Addenda No. 1

SUBJECT: OR6:Wilson R-US26:Hwy 47 WB over PNWR (Vadis)-B512
Wilson River & Sunset Highways
Tillamook & Washington Counties
Structures Project
(Bids to be opened and read October 29, 2009)

The following changes are made to the Project Plans:

1. Drawing Numbers 81657, 81659, 81663 and 81667 are replaced with revised Drawing Numbers 81657, 81659, 81663 and 81667.

| ACCOMPANIED BY DWGS. | | | | CHECKER: <i>Bill Amrhein</i> REVIEWER: <i>Matt Bunner</i> | EXPIRATION DATE: 12/31/09 |  ONE COMPANY <i>Many Solutions</i> SM | DATE June 2009 | CALC. BOOK 6087 | DRAWING NO. 81657 |

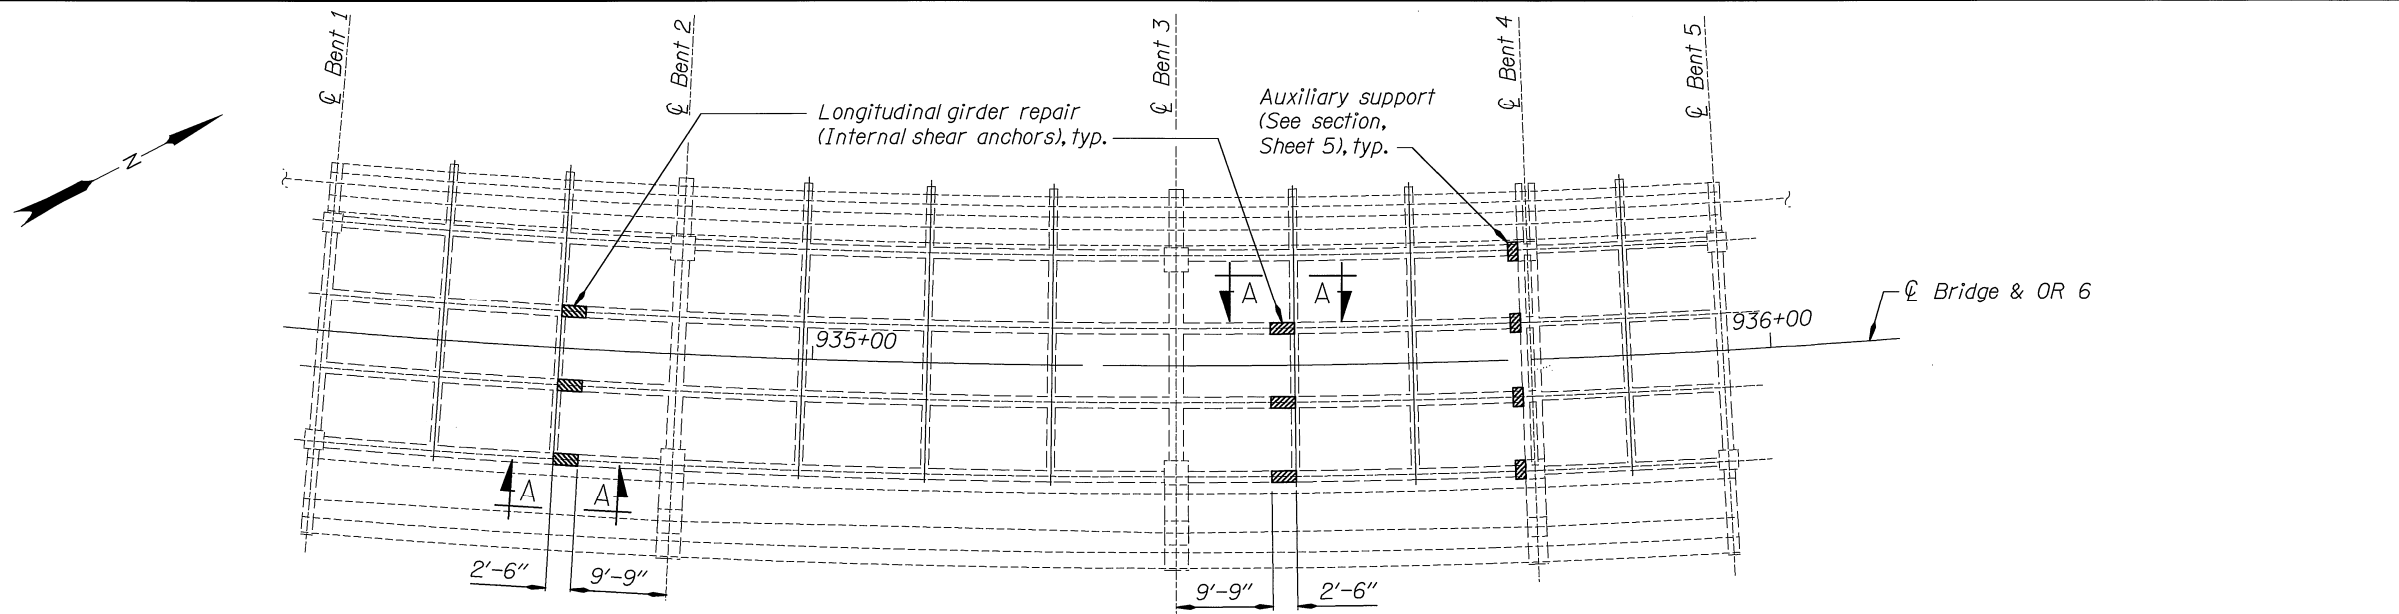
| | 10-22-09 | Bar Diameter Note Revision | EMG | | | | 01872A | | 2 OF 6 |

▲ Provide 1" dia. anchor rods. Provide a high strength resin from the QPL or approved equal. Do not place resin until approved by Inspector.

SECTION B-B
N.T.S.

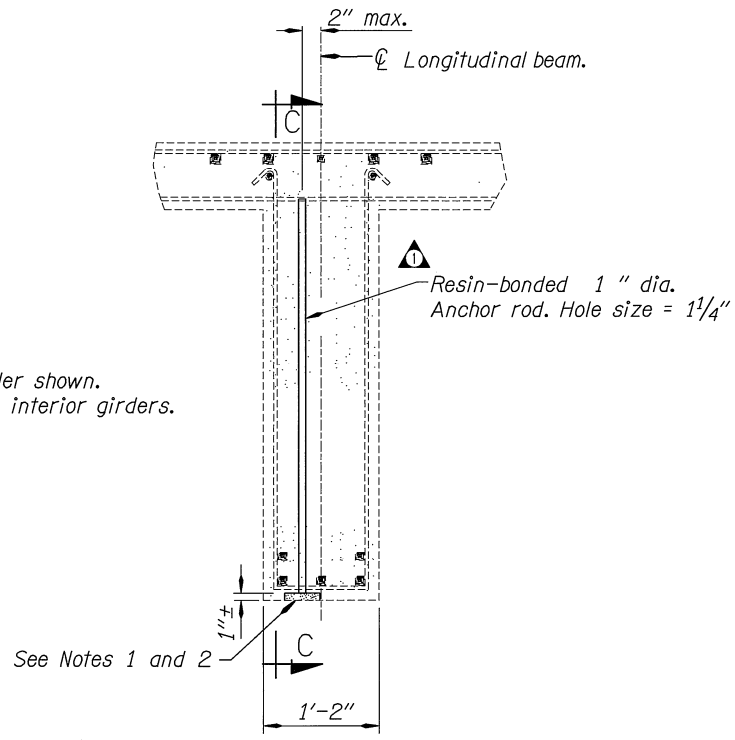
| | 10-22-09 | Bar & Hole Dia. Revision-Section B-B | EMG | | | 01872A | | 4 |

| | | | | | | | | DRAWING NO. | 81663 |

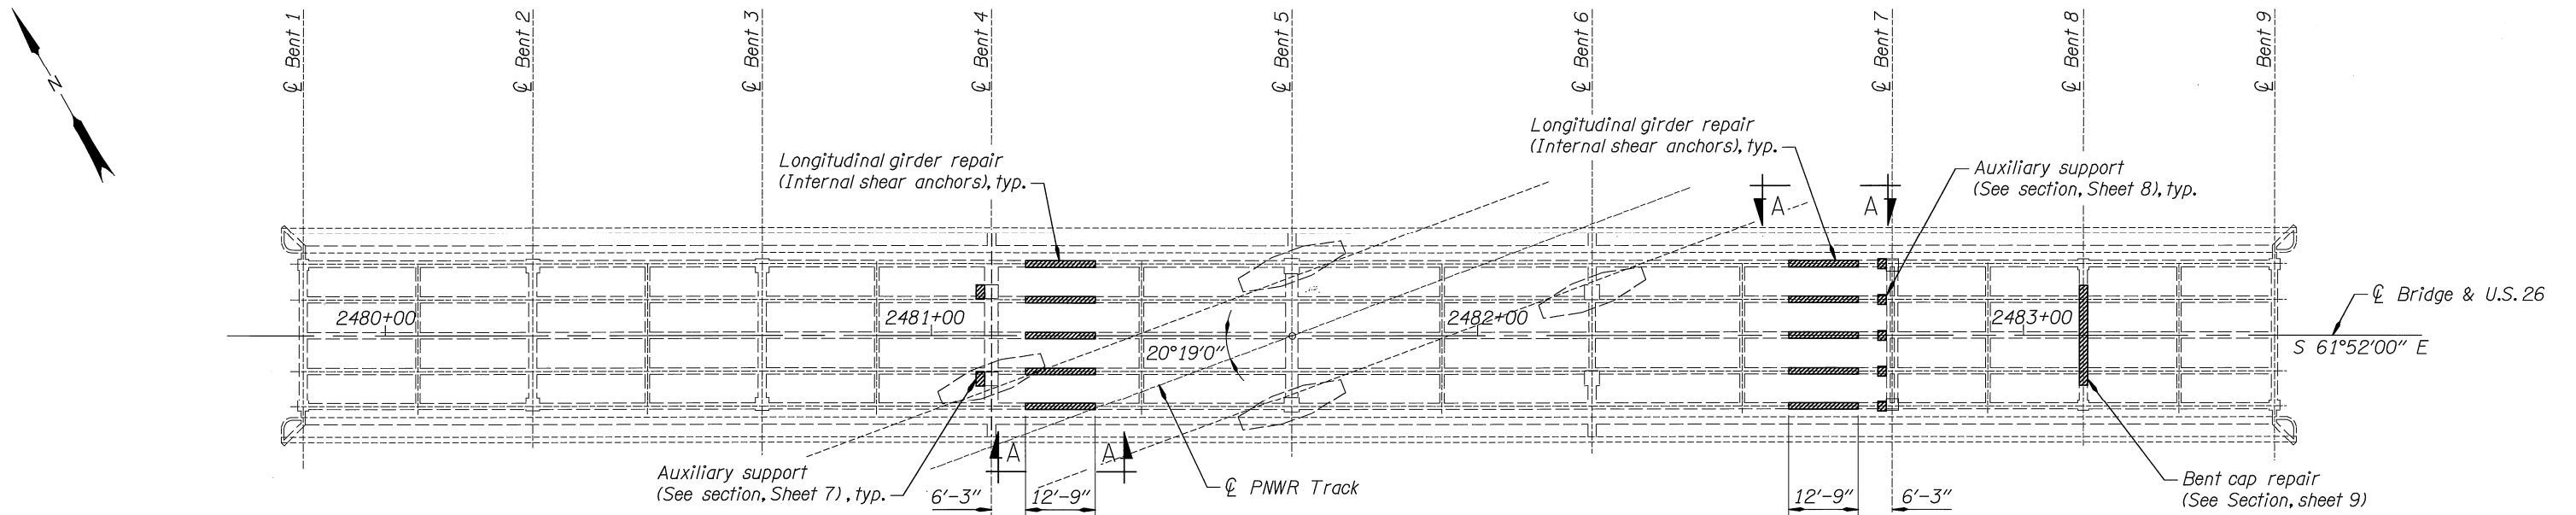
| | 10-22-09 | Bar Diameter Note Revision | EMG | | | | 02367 | | 2 |

⚠ Provide 1" dia. anchor rods. Provide a high strength resin from the QPL or approved equal. Do not place resin until approved by Inspector.

SECTION B-B

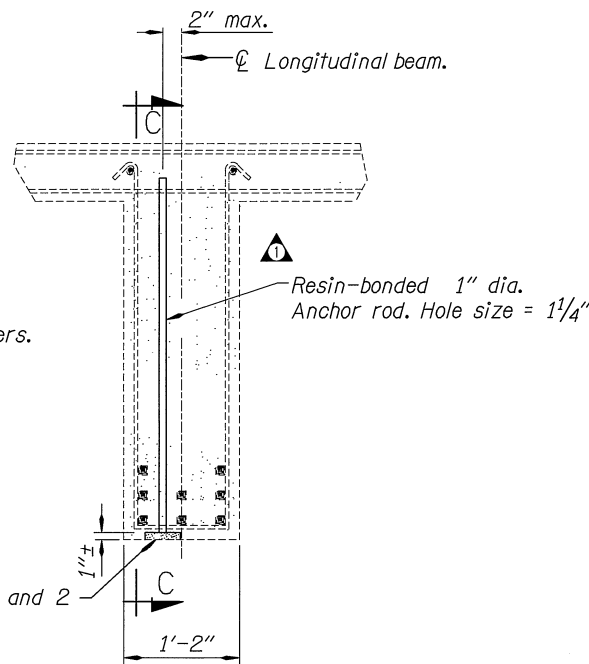
| DATE | 10-22-09 | REVISION | Bar & Hole Dia. Revision-Section B-B | BY | EMG | STRUCTURE NO. | 02367 | HWY. 47 WB OVER PNWR (VADIS) OR6:WILSON R-US26:HWY 47 WB OVER PNWR (VADIS)-B512 SUNSET HIGHWAY (HWY. 47 WB) (MP 55.72W) WASHINGTON COUNTY | SHEET 6 OF 10 |
